## **NUCLEAR REGULATORY COMMISSION**

Title:                   Advisory Committee on Reactor Safeguards  
                              ESBWR Subcommittee

Date:                  Thursday, October 20, 2016

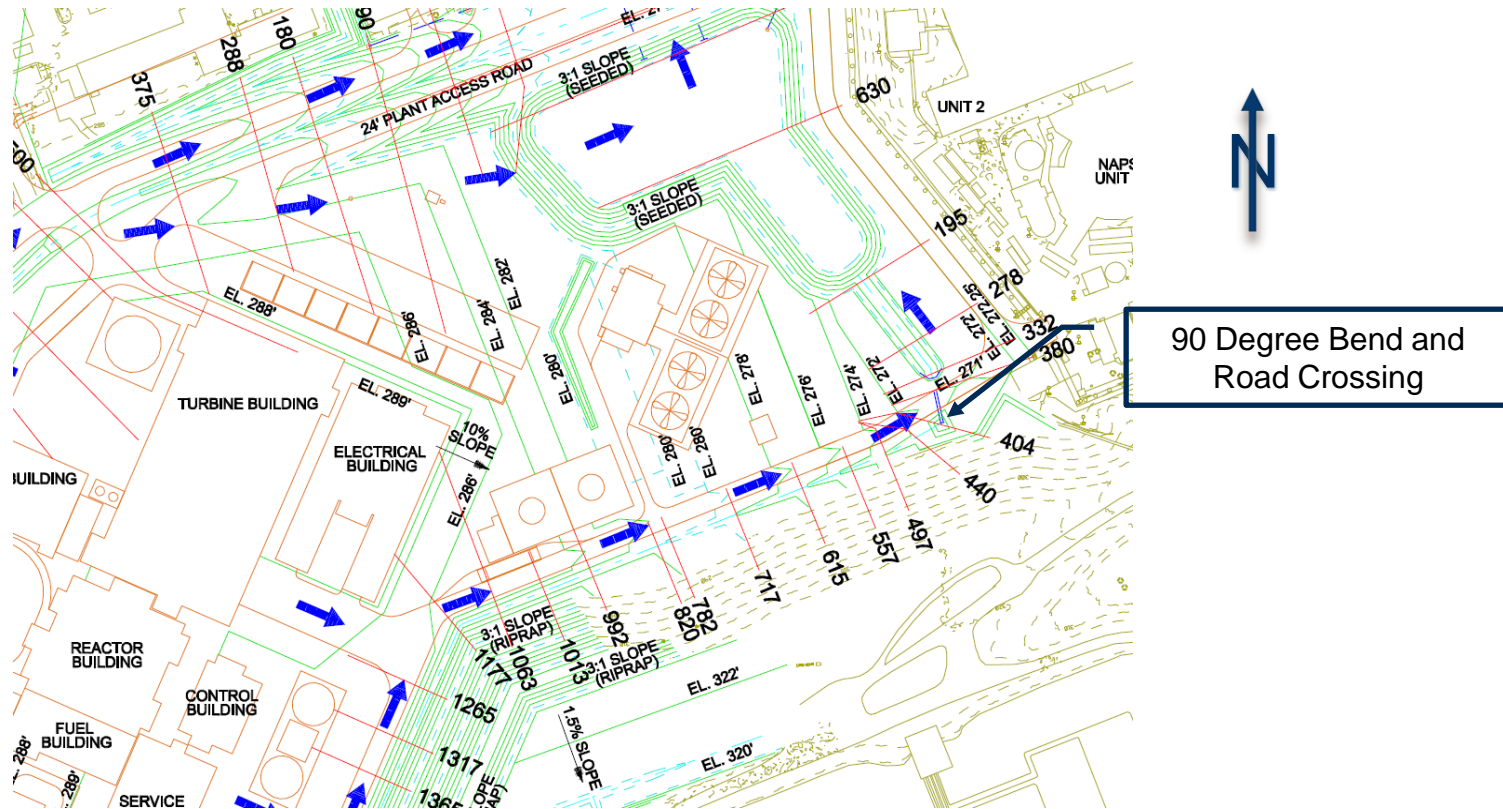
Open Item 2.4.2-3: Staff reviewing the response to RAI 02.04.02-3 providing design measures for South Ditch 90-degree abrupt bend addressing:

- 2 dimensional effects
- Superelevation
- Hydraulic jump

1 all of the adverse conditions that were discussed  
2 in that RAI now no longer exist. So, the  
3 resolution to this RAI and this open item was a  
4 change in the layout that eliminated the adverse  
5 conditions. Go to the next slide.

Current Site Layout  
Adapted from FSAR Rev. 9 Figure 2.4-203

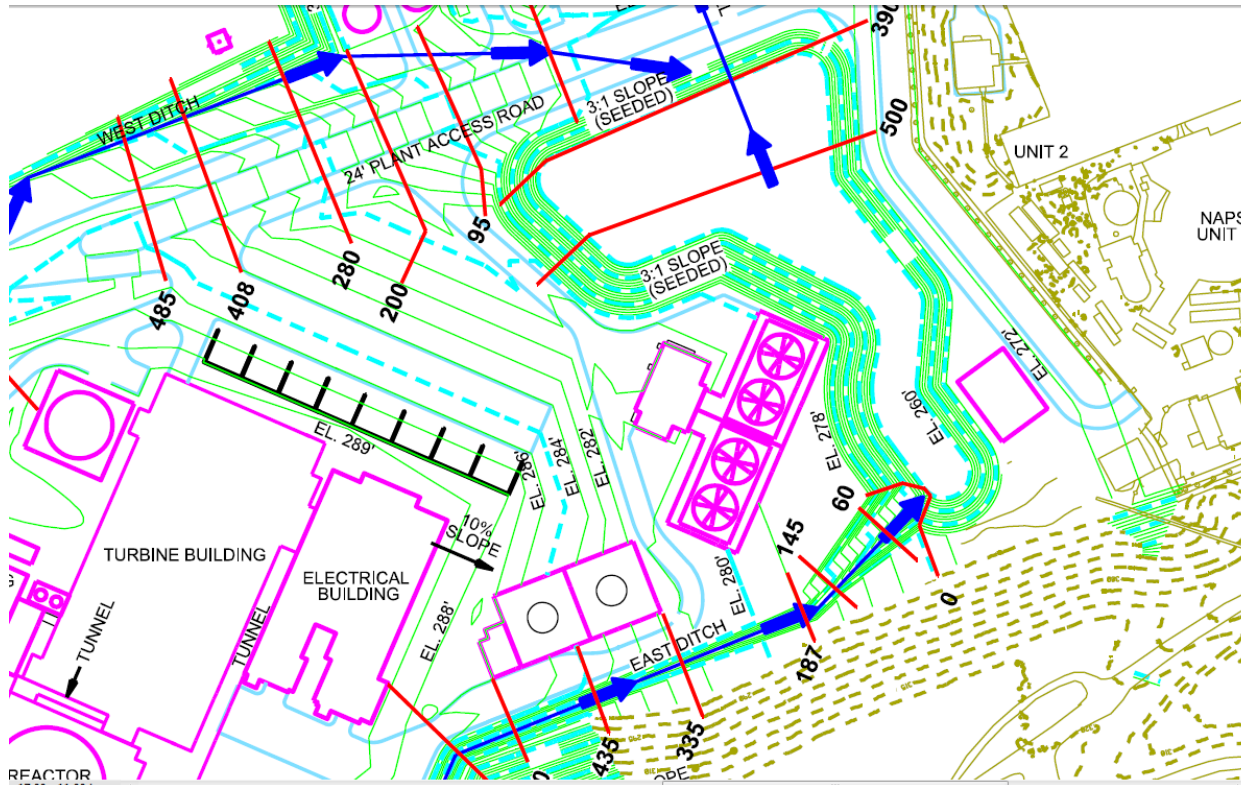
Previous Site Layout  
Adapted from FSAR Rev. 2 Figure 2.4-203

NA3 FSAR Figure 8.1-1R

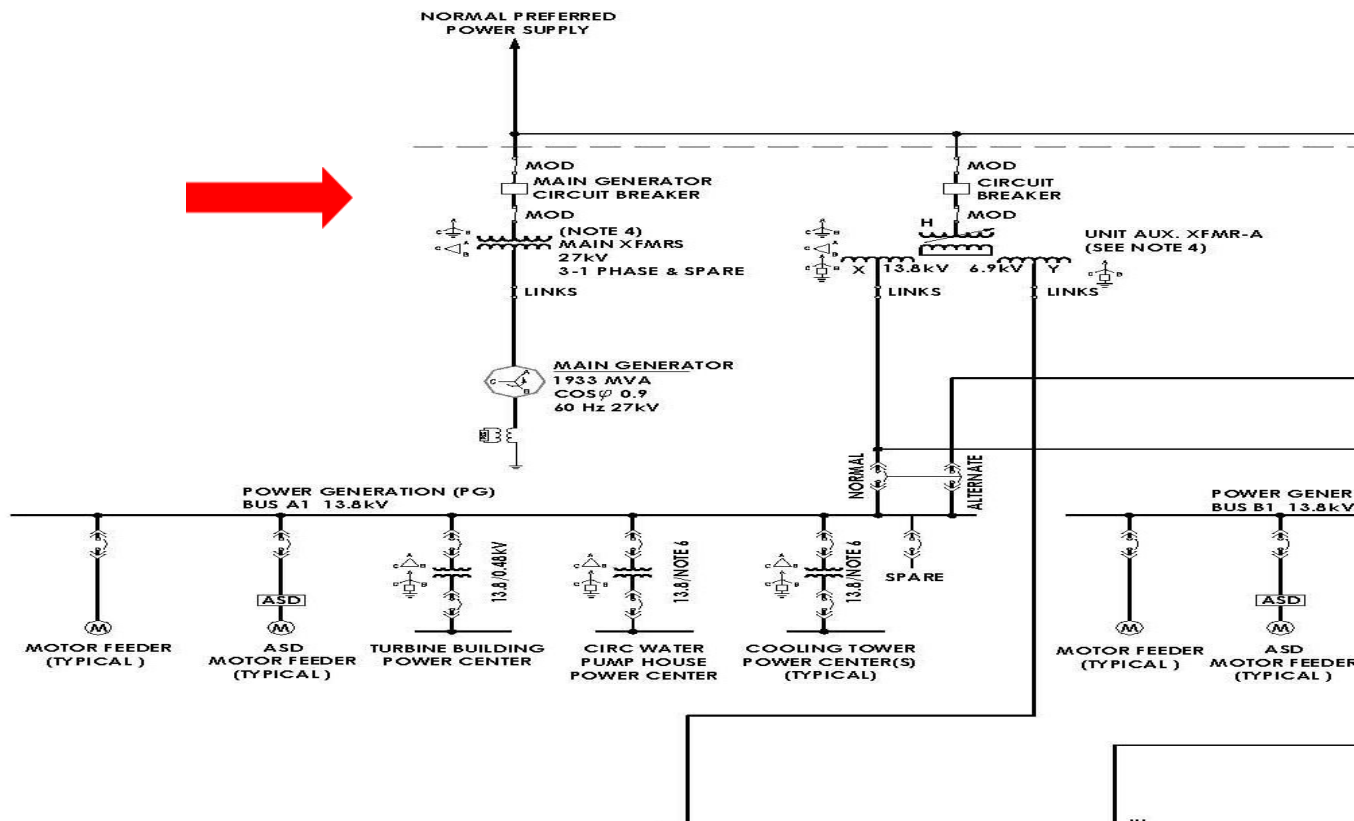
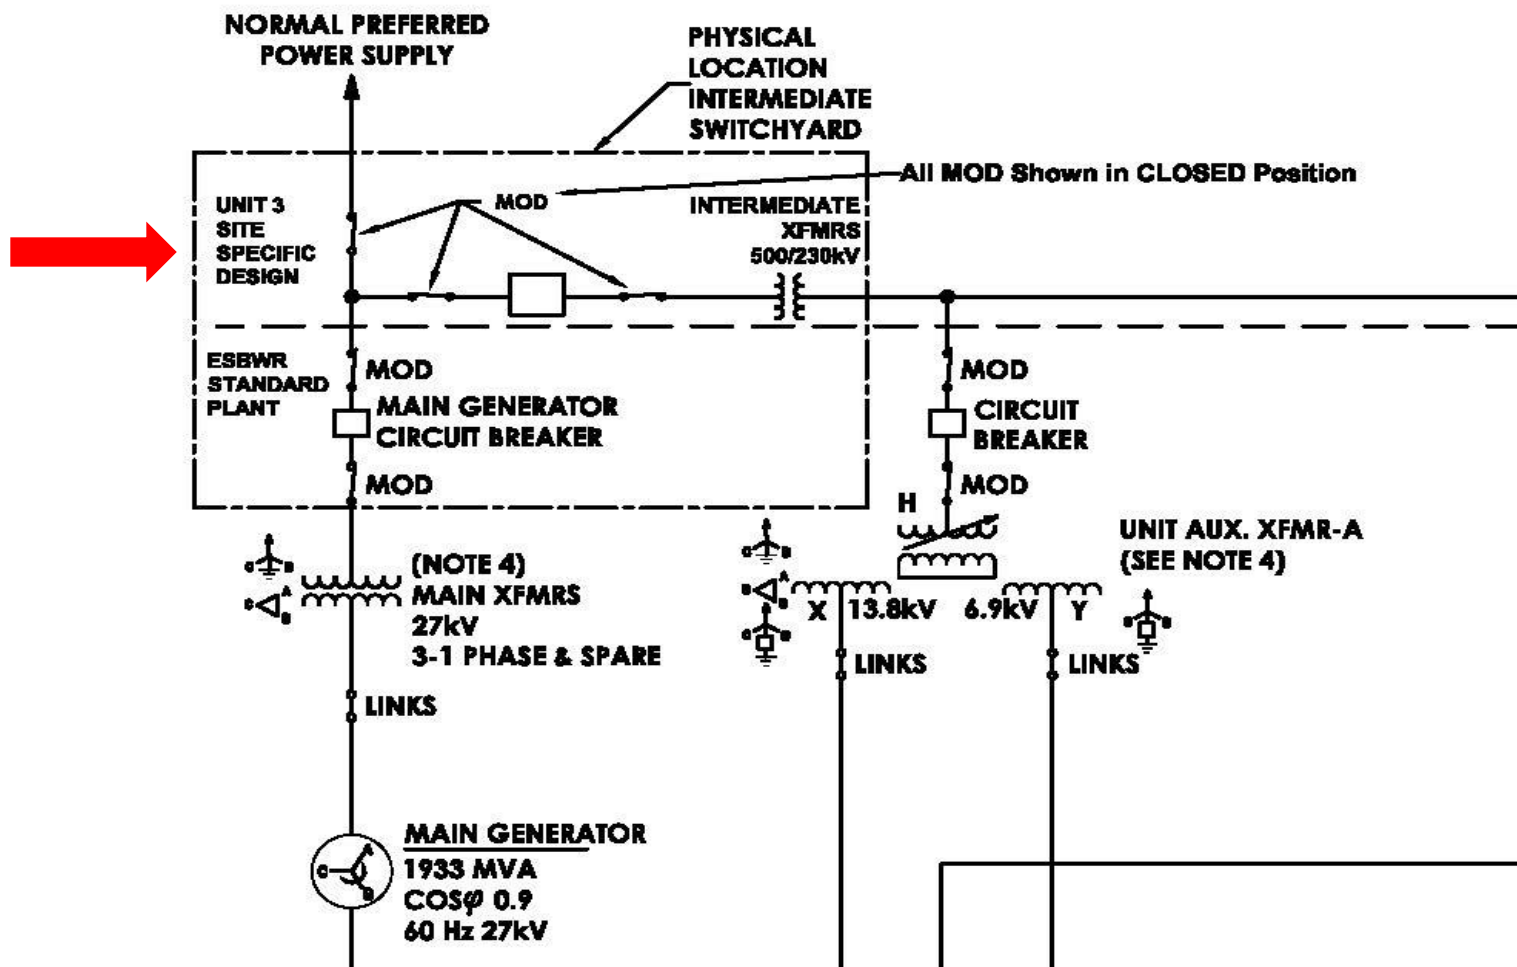
- Revised FSAR switchyard Figures 8.1-1R (Departure 8.1-1 and Exemption 2) and 8.2-201 to reflect location of the main generator circuit breaker and the intermediate transformer in the intermediate switchyard
